DRAWING CHECKED SPECIFICALLY FOR:	CAPACITY TO FILL LEVEL BEFORE DECORATING	20oz. NET WT. (6EL)
NECK FINISH	CAPACITY TO FILL LEVEL AFTER DECORATING	
WEIGHT	OVERFLOW CAPACITY BEFORE DECORATING	665ml ± 13
CAPACITY	OVERFLOW CAPACITY AFTER DECORATING	
MATERIAL		
SPECIAL REQUESTS		
PRODUCT DESIGN TO BE APPROVED BEFORE MOULD CAVITIES ARE MACHINED.		
APPROVED BY	DRAWN BY: D	DESC. 20oz. GEL TOTTLE
DATE	SCALE: 1-1	DATE: SEPT. 9/03
This drawing subject to standard industry tolerance S.P.L.	BOTTLE MAT'L: PVC	DRAWING NO. 3-5782-PA
	CAD NAME: PD\5500\3-5740	MOULD NO. 3-28094-3

TEMPORARY DRAWING—NOT RELEASED FOR PRODUCTION  
 THIS IS A SUGGESTED DESIGN FOR CUSTOMER APPROVAL.  
 FINAL SIZES AND VOLUME ARE SUBJECT TO MOLDING  
 SPECIFICATIONS AND PRODUCTION QUALIFICATIONS.

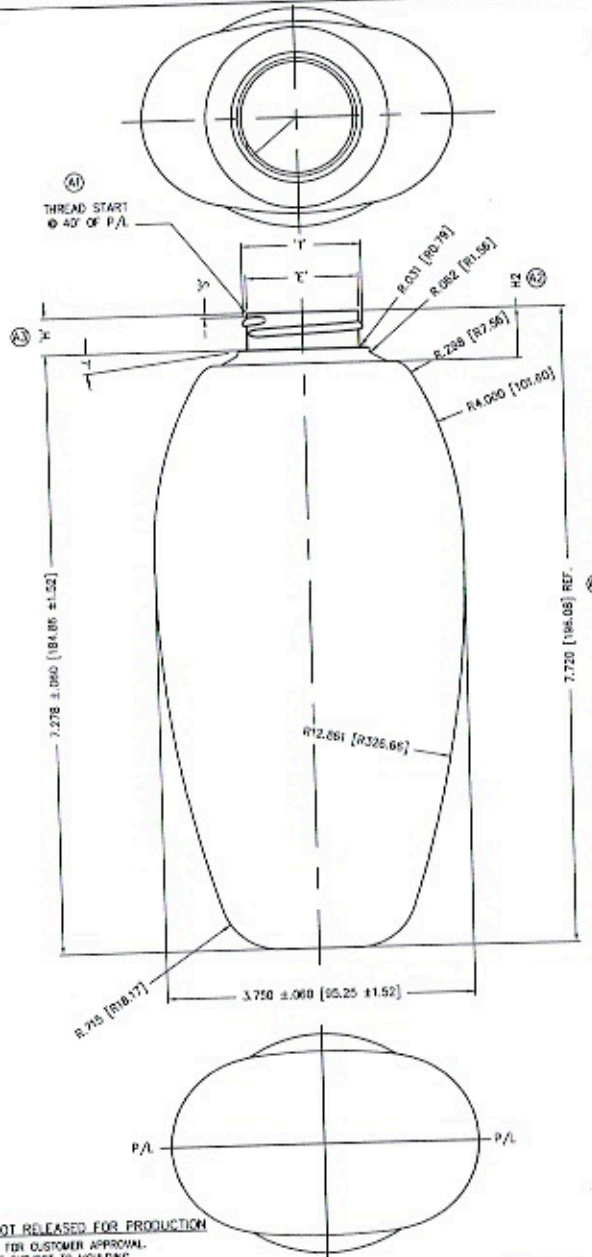
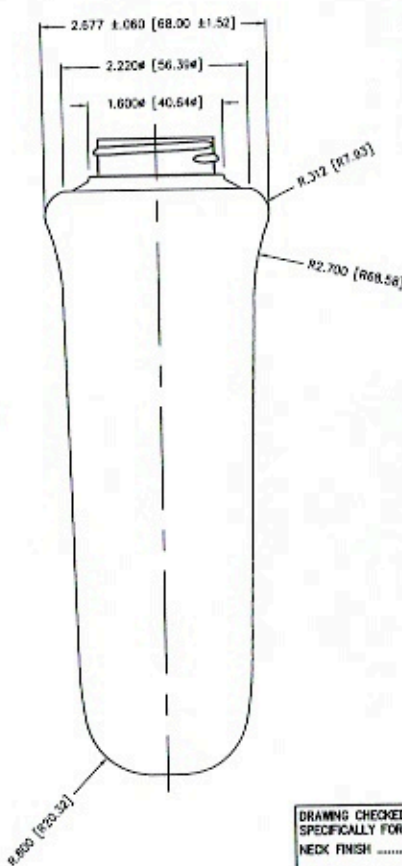
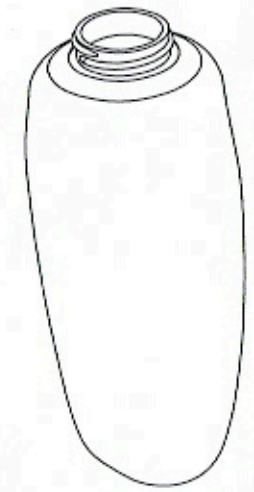
(A4)	P.O.	7.720" WAS 7.680"	OCT 24/03
(A3)	P.O.	"H" 0.443" WAS 0.403"	OCT 24/03
(A2)	P.O.	"H2" ADDED	OCT 24/03
(A1)	P.O.	THREAD START CHANGE TO 45° OF P/A, AS PER ENG.	OCT 24/03
